Subject: Response to the FCC Correspondence Reference # 21583 / 21584 for additional information on RIM BlackBerry Wireless Handheld FCC ID: L6AR6230GE, 731 Confirmation # TC493009

The following addresses the comment on your **Correspondence Reference # 21583 / 21584**, dated July 12, 2005.

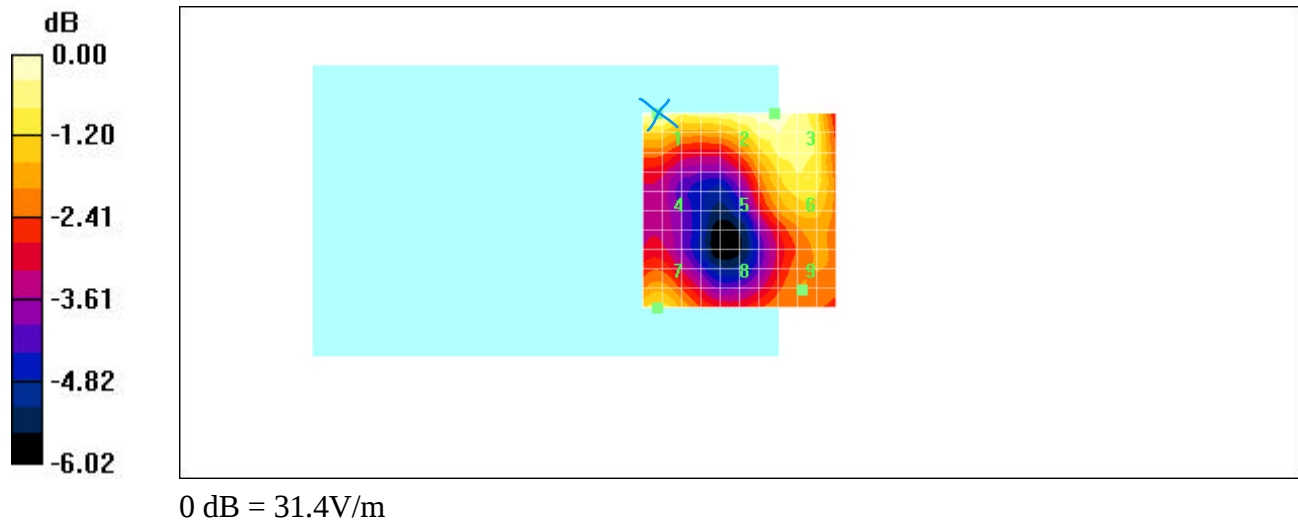
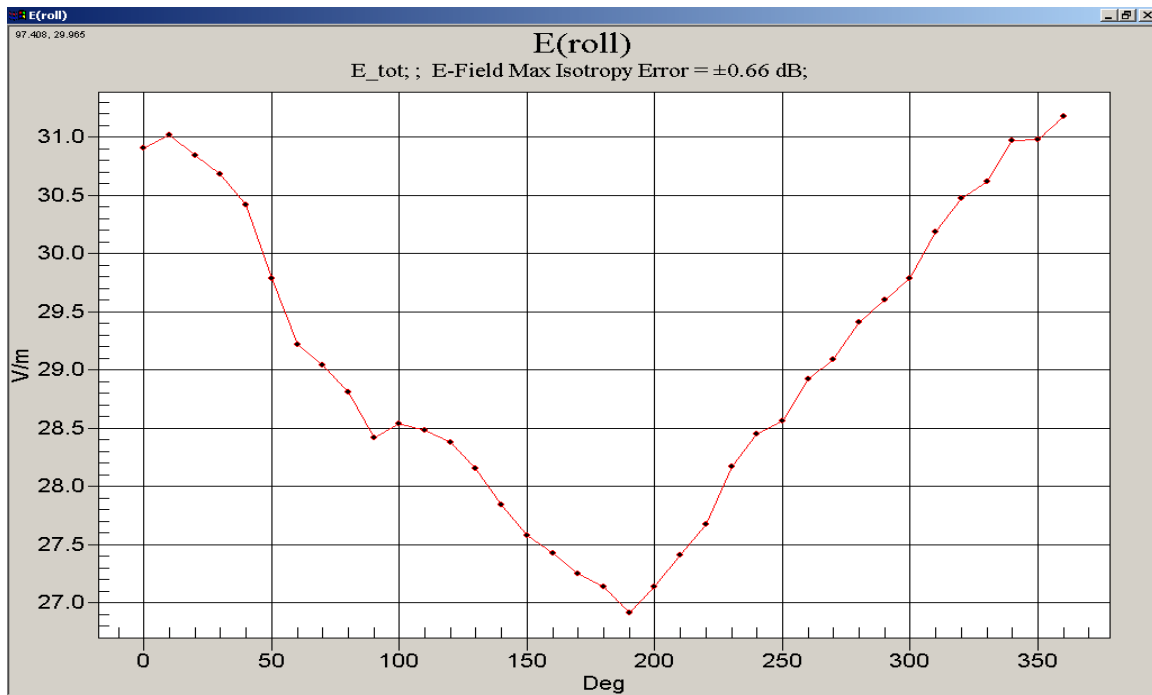
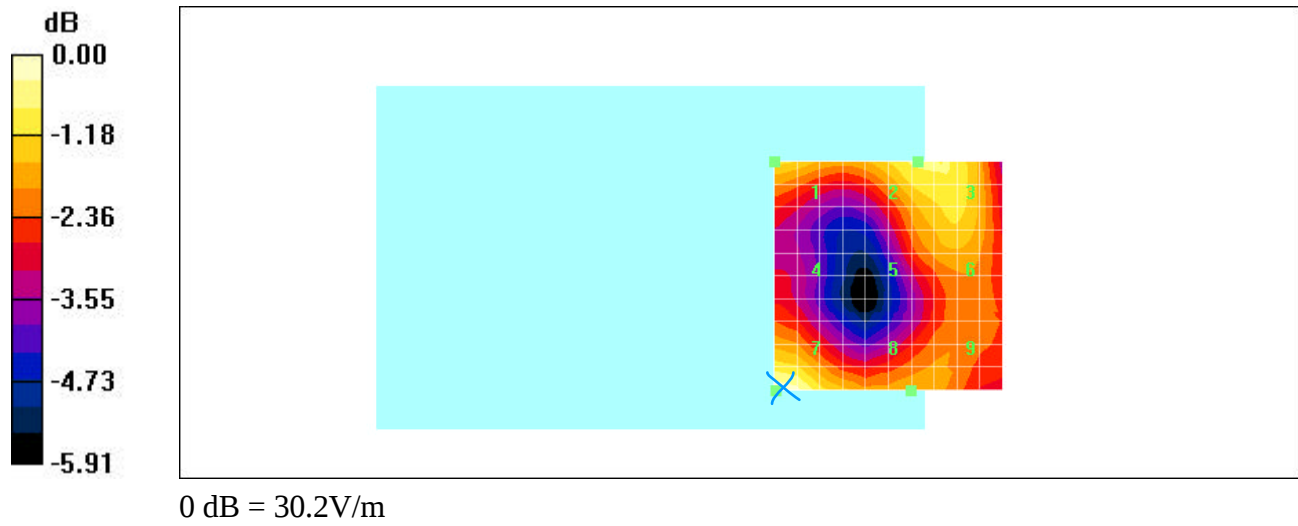
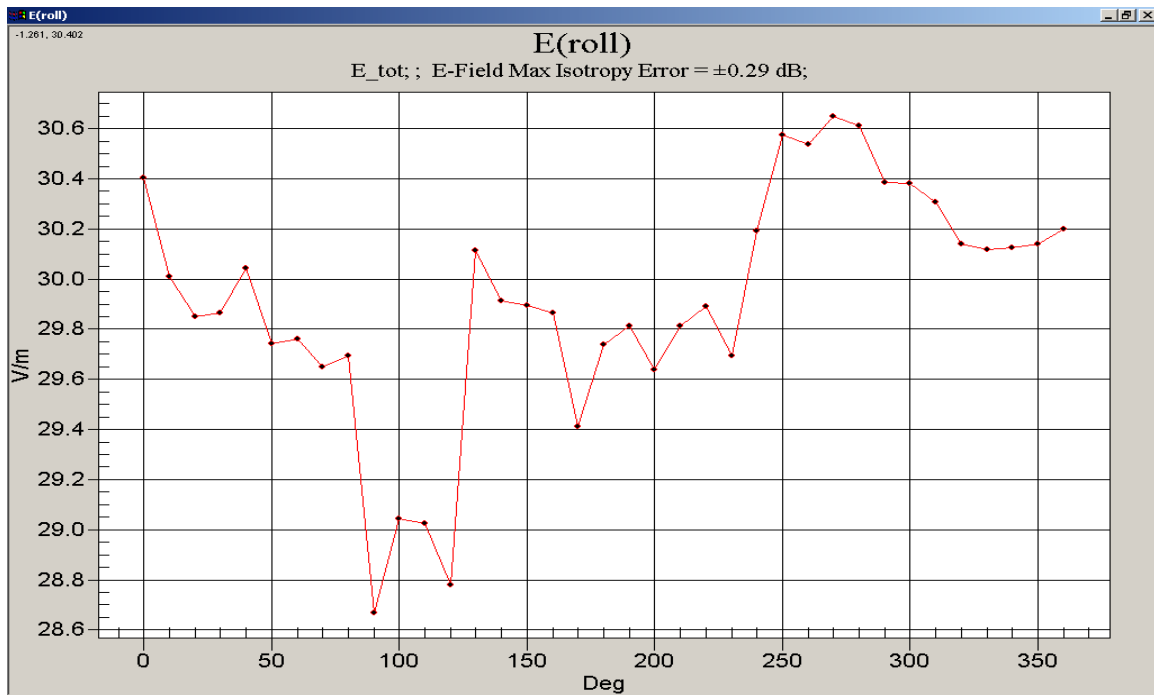
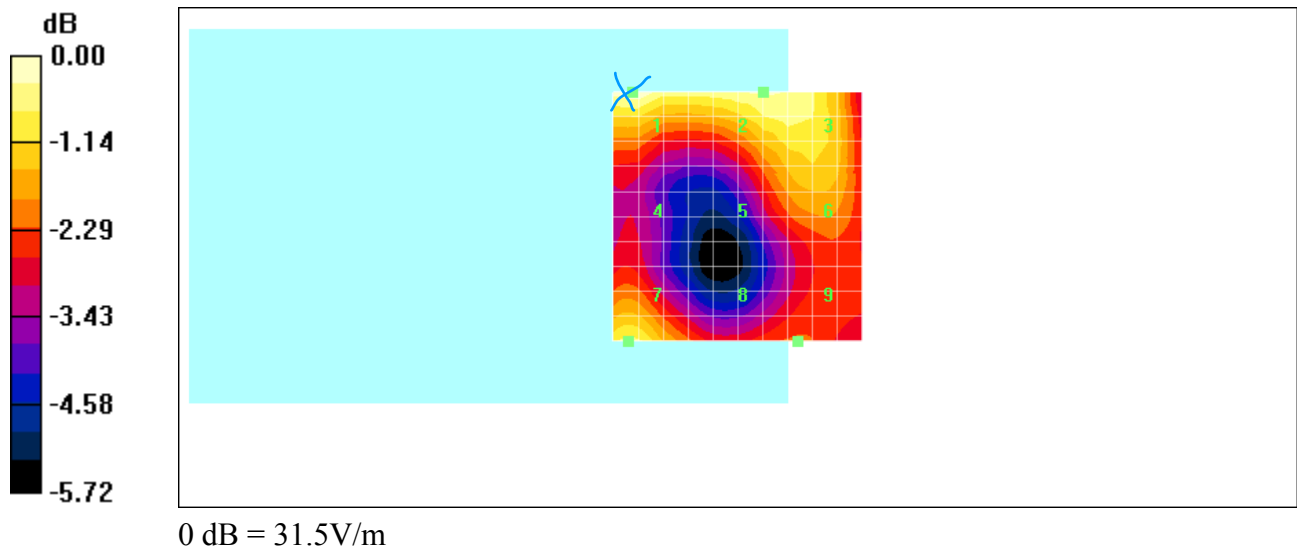
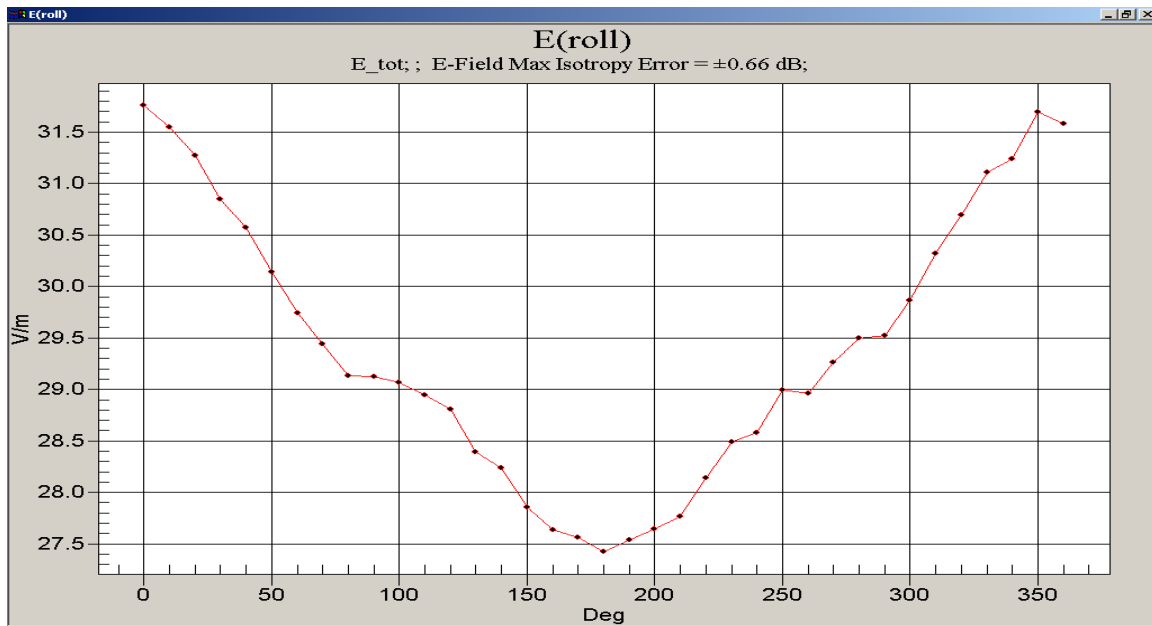
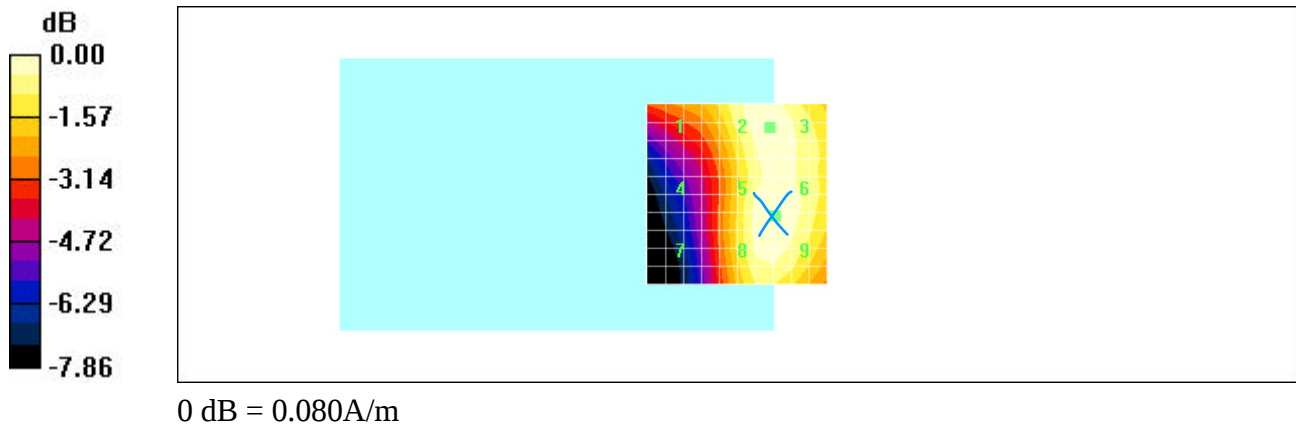
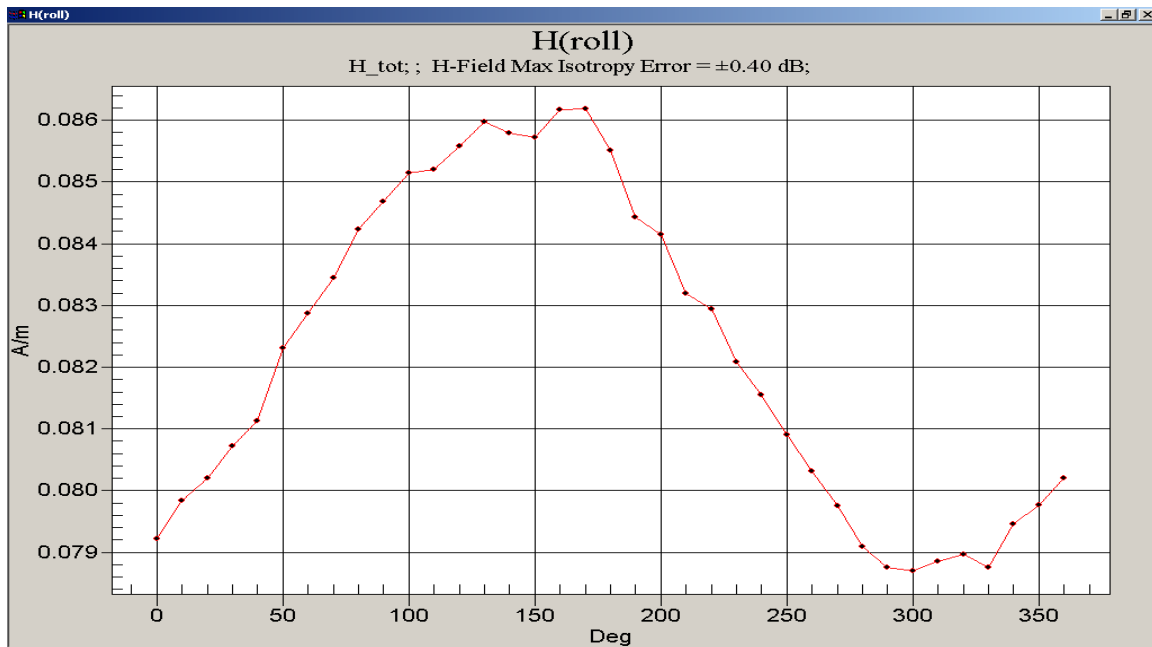
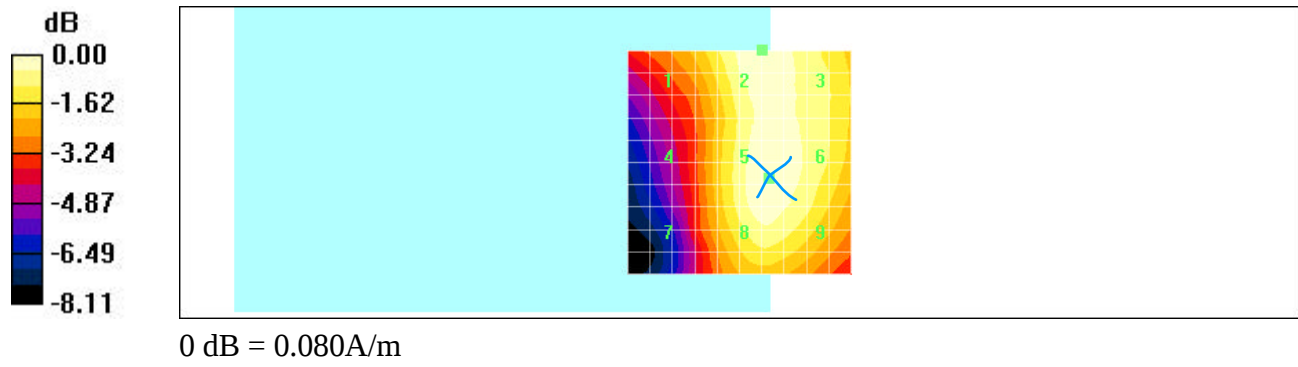
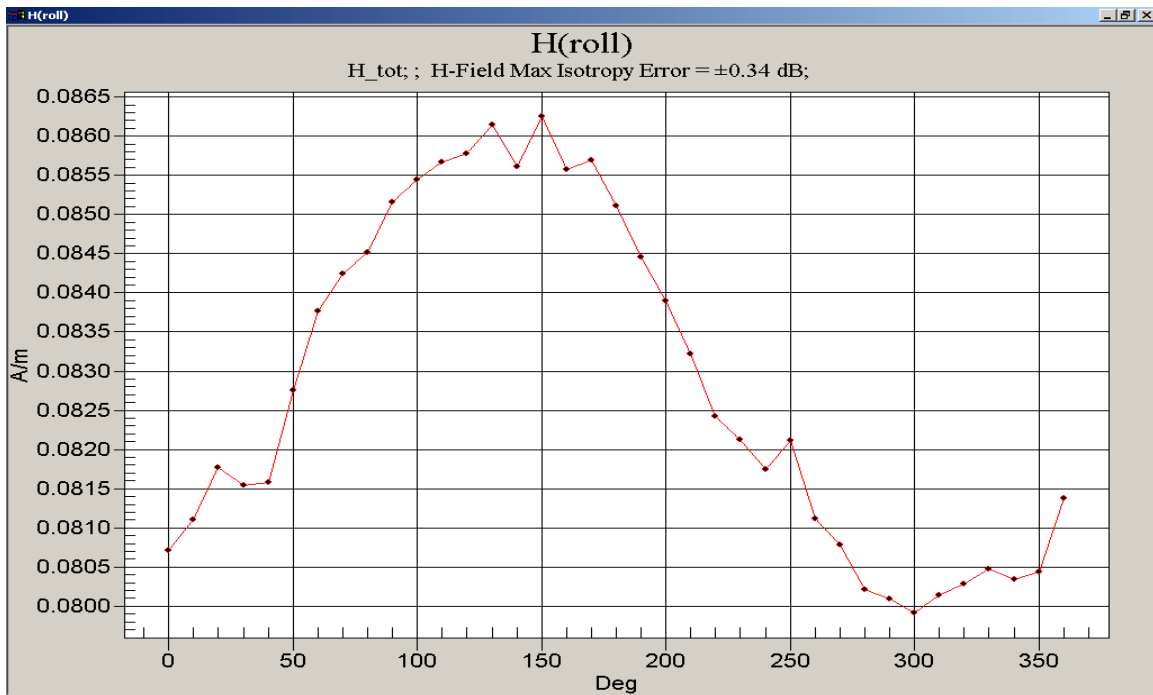
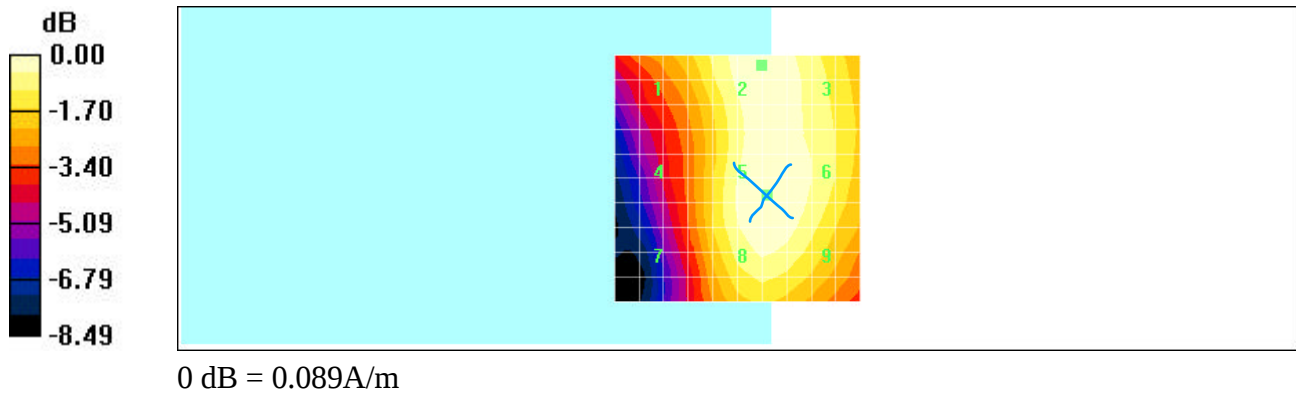
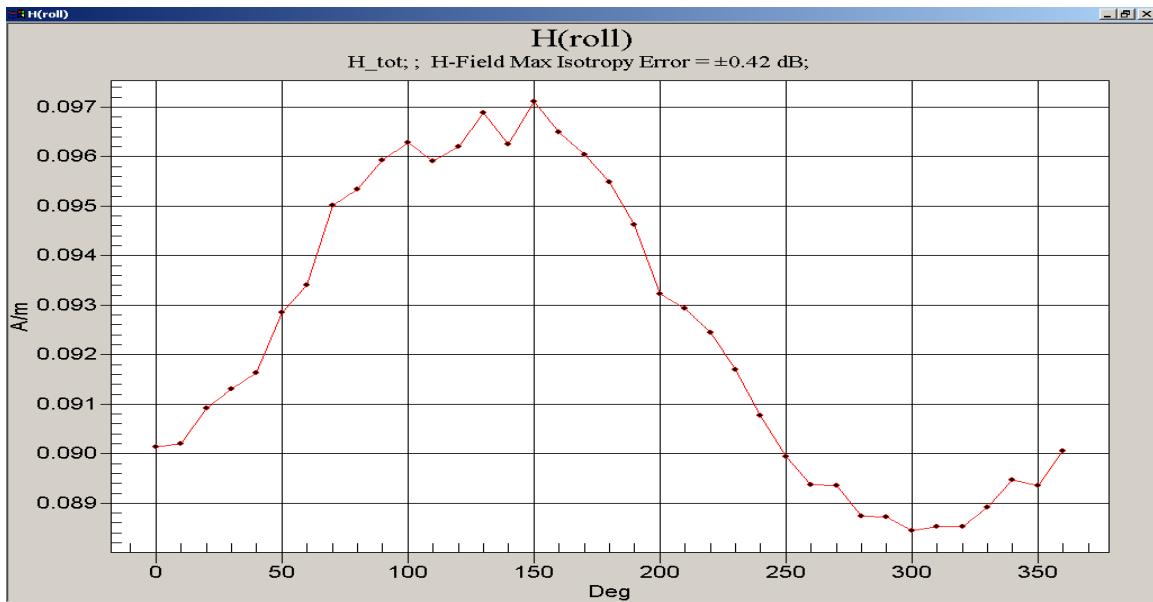
**II Regarding your answer to question 1, please update the contour plots to show the grid lines and some means to indicate the excluded blocks.**

In Annex A.4 of the test report number RTS-0228-056-01 rev 02, the grid lines are shown, and exclusion blocks are shaded yellow. Please also see the plots below.

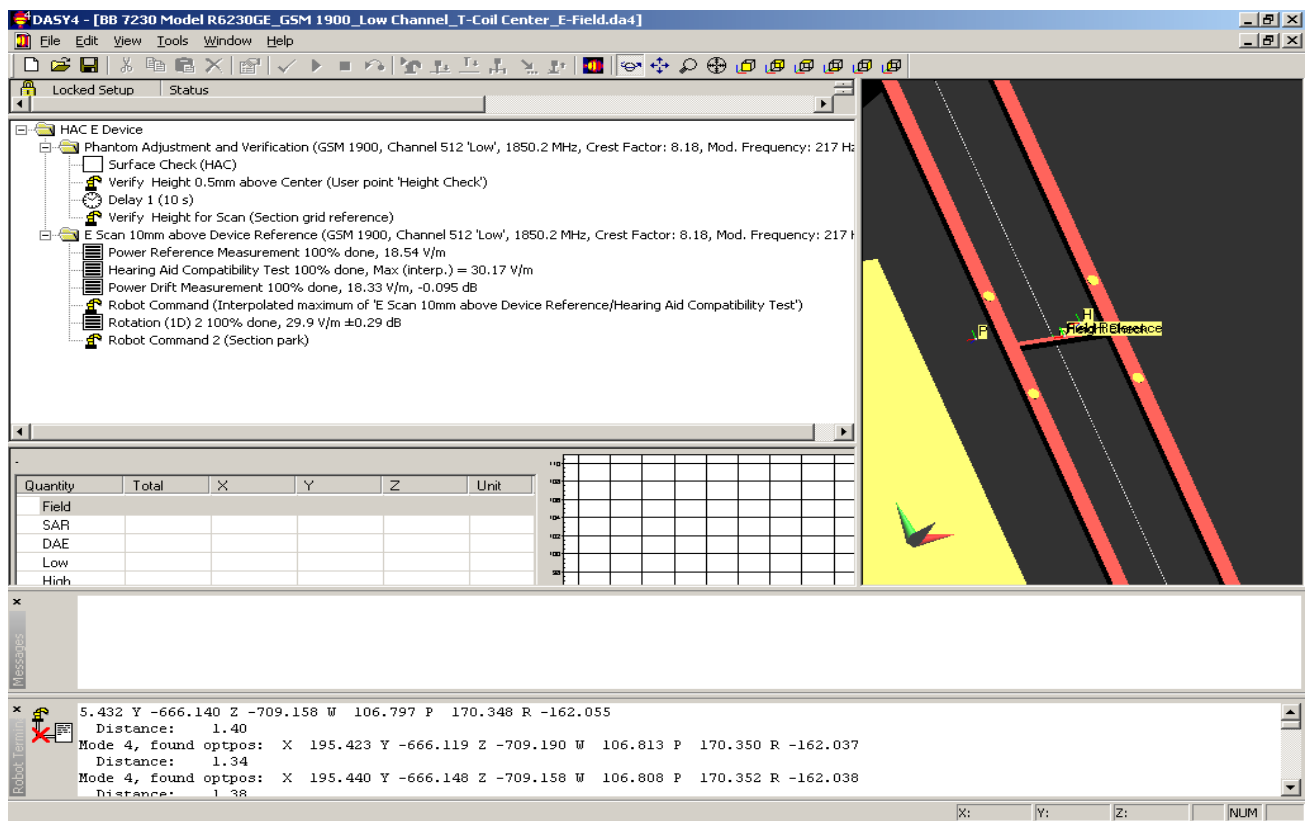
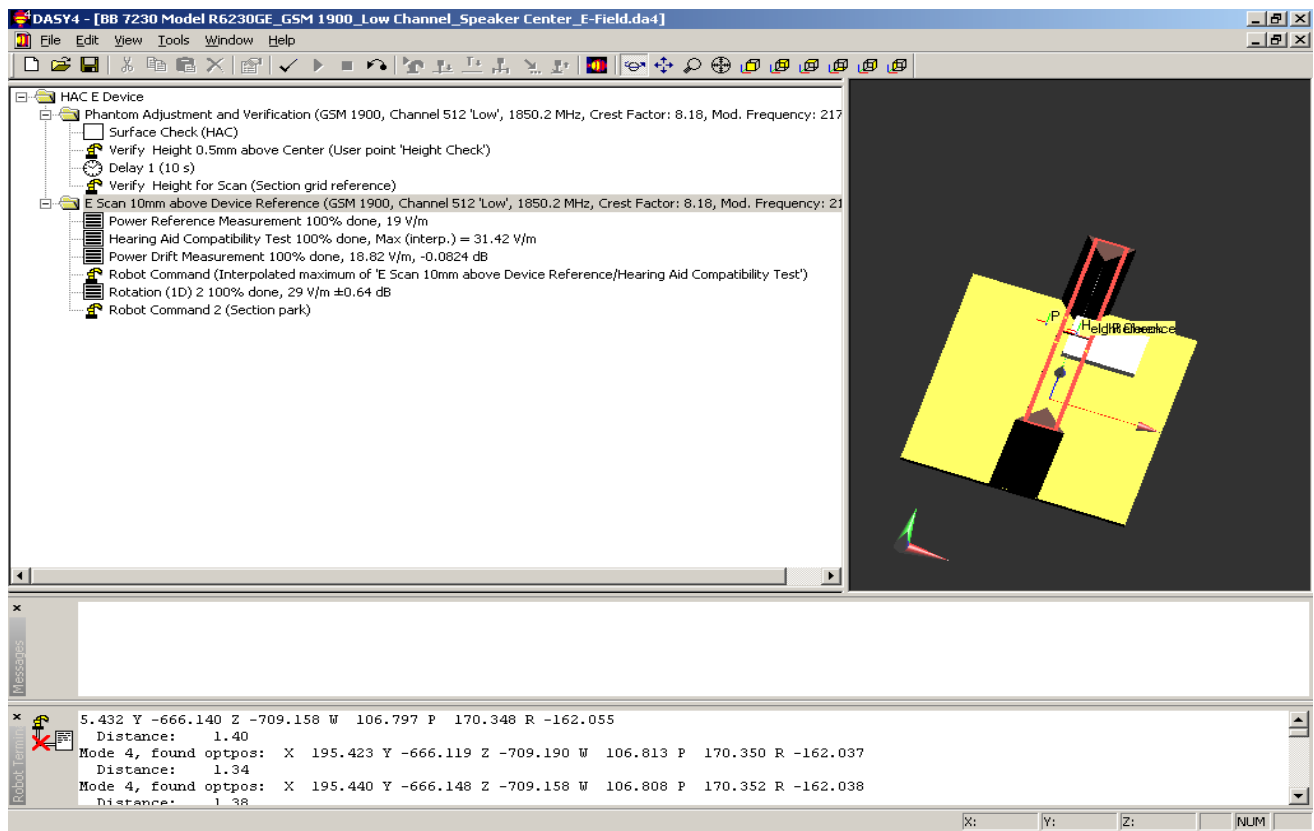
#### C) Please provide and justify a target value for AM and WD signals.

There are no target values provided by the manufacturer of the measurement system or the ANSI C63.19 standard. However, from the ratio of average input powers, the modulation factor target was determined for AM and GSM signals. The manufacturer target value for CW was divided by the theoretical linear modulation factor to find target values for AM and WD signals.
